## Evaluation of proposed move for Water Right No. 10798

Proposed: Move water right no. 10798 to a new well location, 528 ft to the southeast.

Data Set: C:\Users\trevora\Documents\2022\_moves\10798\10798 Proposed.aqt

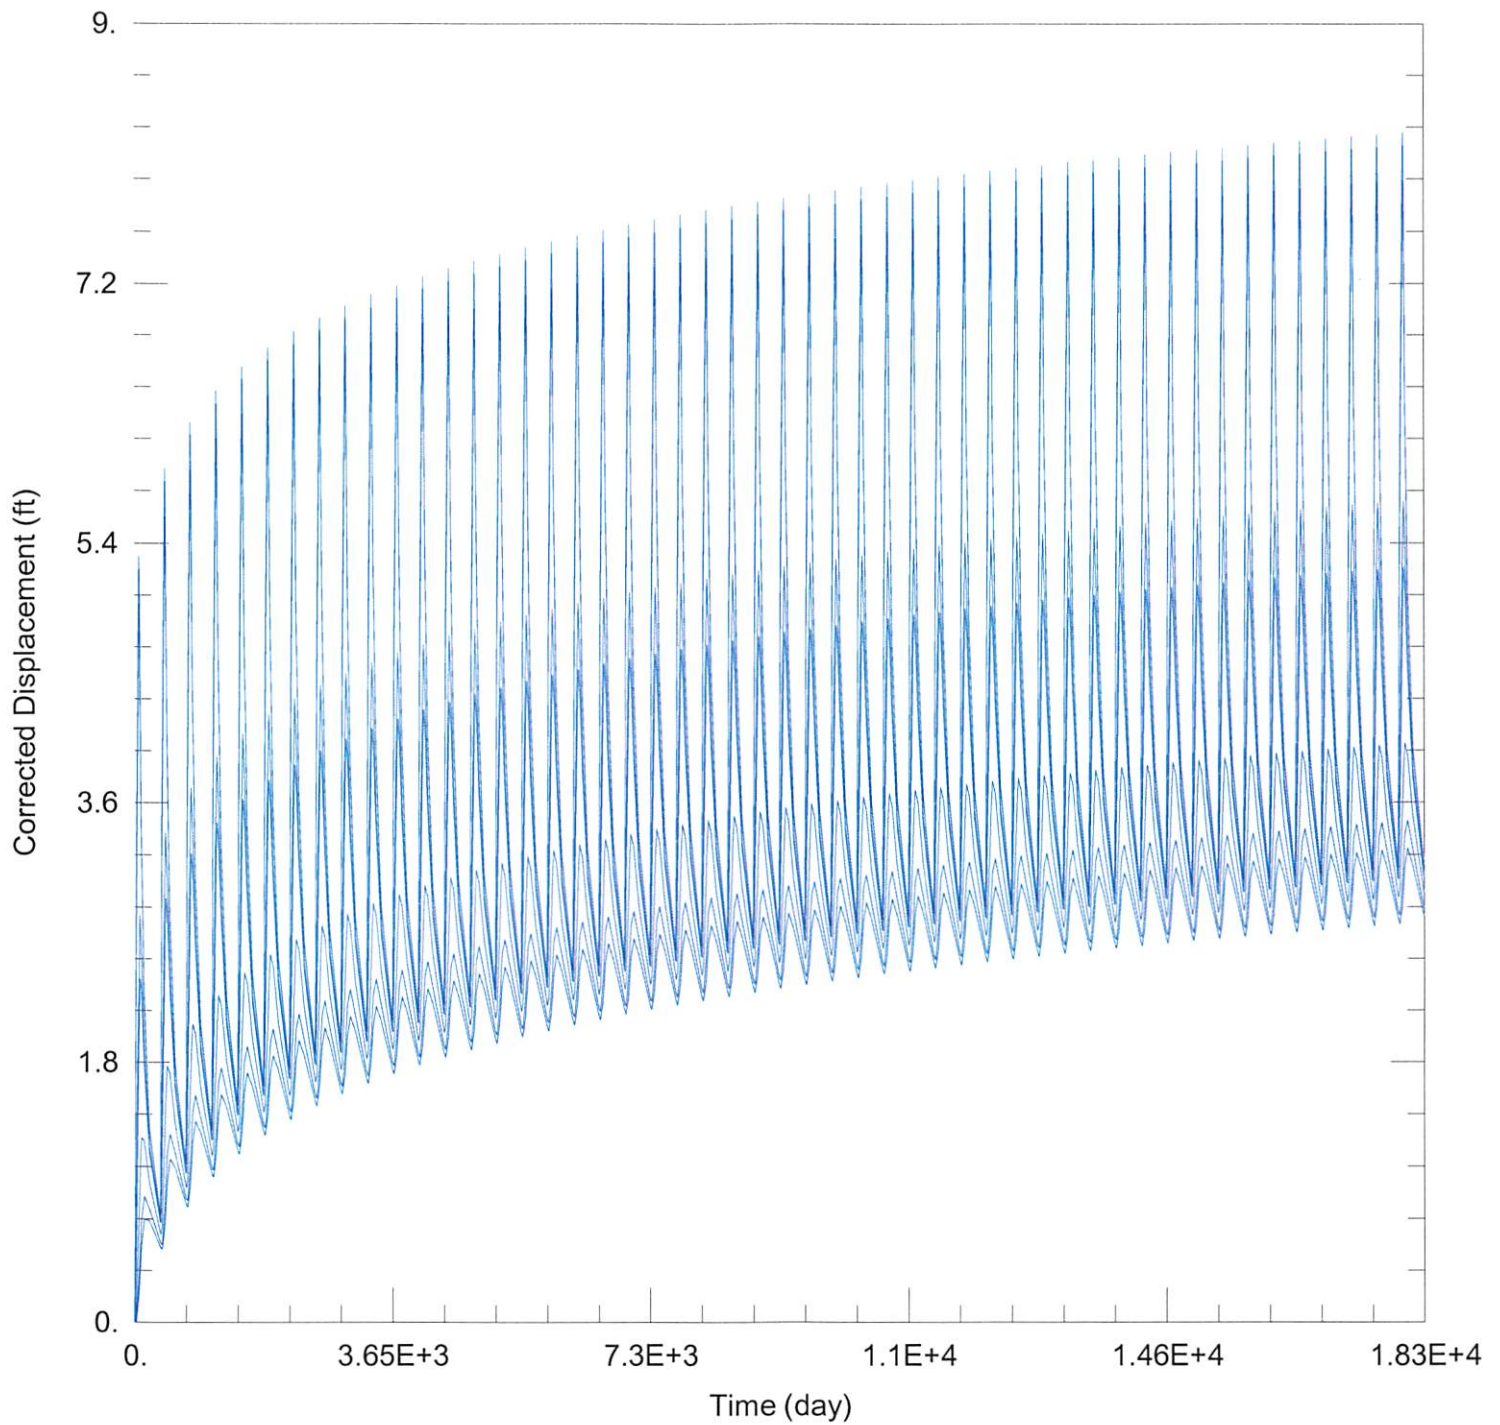
Net drawdown exceeds the drawdown allowance of 3.5 ft for all wells under water right numbers 9311, 21075, and the domestic well in section 6-31-32. Critical well analysis was conducted for those wells.
